BULLETIN

NUMBER 9

SUBJECT: Tail Surface Bracing

MODELS AFFECTED: E2, F2 and J2 "Cubs" up to Serial No. 1500

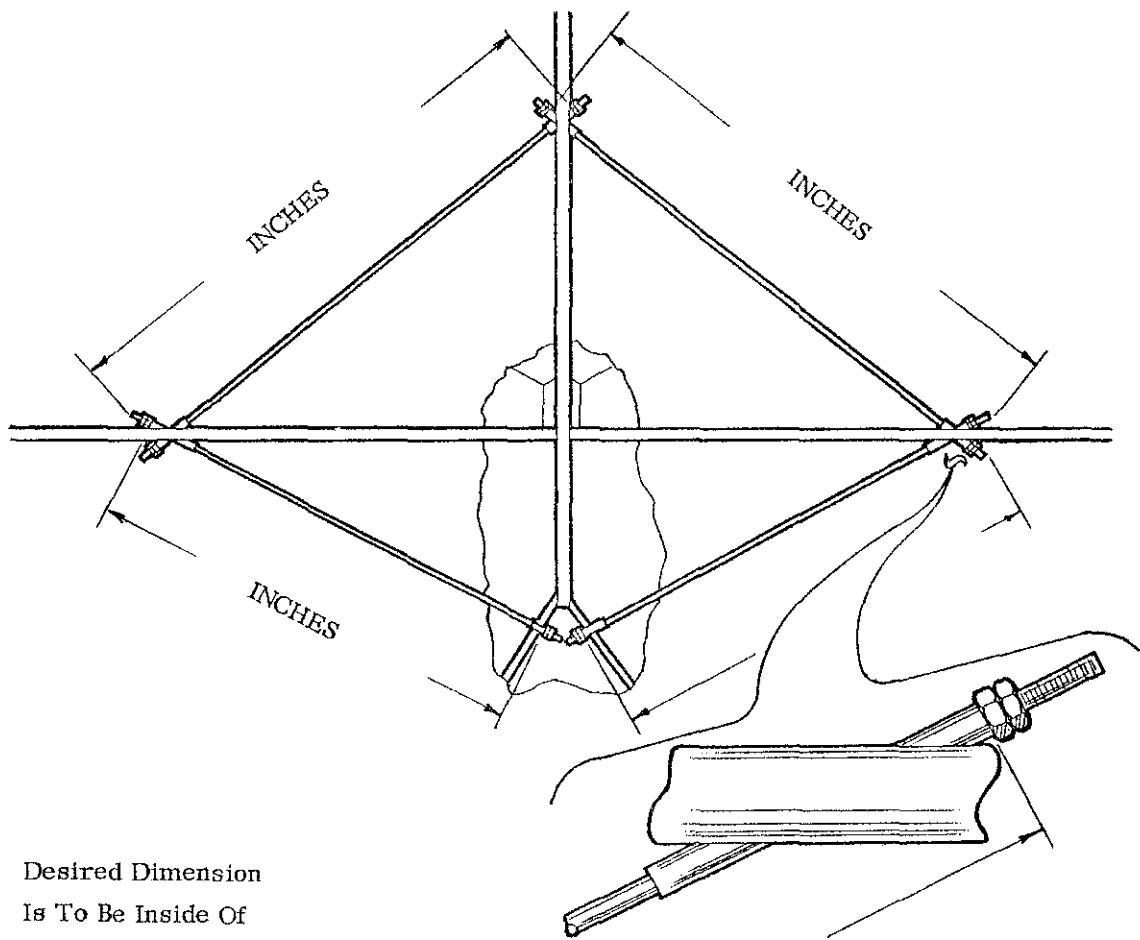
"Cubs" of Serial No. 1500 and up have this same size wire, but the end fittings are of a different design, making the bracing system more flexible and better able to absorb vibration. In order to accomplish the same purpose where the older type of fitting has been used, which carries the wires clear through the fin and stabilizer spars in bushing tubes, it will be necessary to replace the solid tie rods with a standard cable.

To facilitate this replacement in the field, fittings for the stranded cable are being made up at the factory such that the new flexible wires may be readily installed in the same fittings as used for the solid wires.

Note: Desired Dimension
Is To Be Inside Of
First Nut As Shown At
Right
